Groundwater Application Review Summary Form

Application # G- 18739

To: Kristopher Byrd, Well Construction and Compliance Section Manager
From: Joel Jeffery, Well Construction Program Coordinator
Subject: Review of Water Right Application G-18739
Date: May 29, 2019

TO: Water Rights Section Date 05/22/2019
 FROM: Groundwater Section Dennis Orłowski
 Reviewer's Name
 SUBJECT: Application G- 18739 Supersedes review of _____
 Date of Review(s)

Water-Level Trends in Nearby Wells

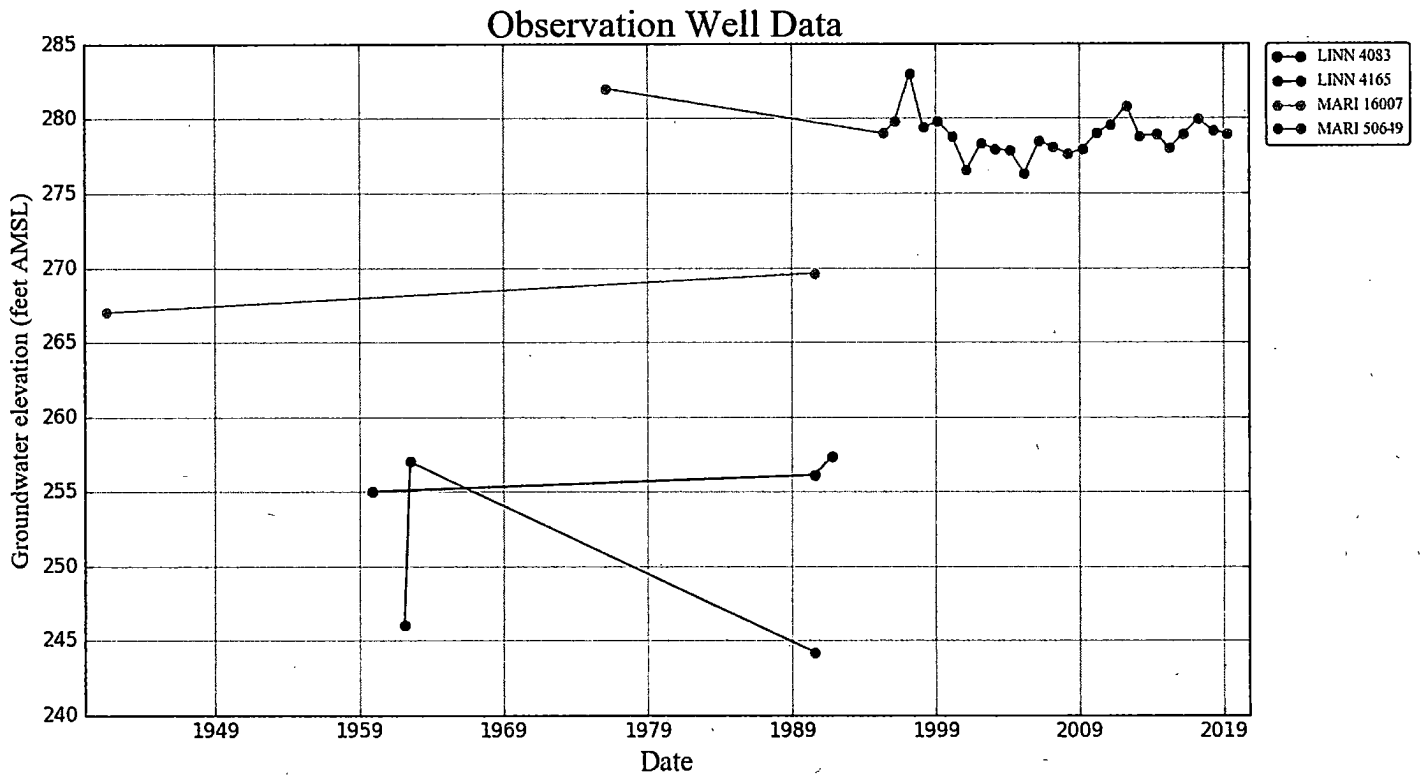
Groundwater development is relatively low in this area. Limited groundwater data shows general stability from measurements in one nearby well, MARI 50649. The unconfined alluvial aquifer system is highly transmissive due to thick water-bearing deposits of coarse gravel (cobbles to boulders) and sand and the efficient hydraulic connection to the North Santiam River (Conlon and others, 2005; Gannett and Caldwell, 1998). Due to the strong connection to the river, much water pumped by the proposed POAs would likely originate from the river, particularly during high streamflow conditions that exist during the wet season period that corresponds to this application's proposed period of use (October through May). **These factors, particularly the period of use that would not conflict with dry season irrigation pumping, would greatly mitigate potential injury to other users.**
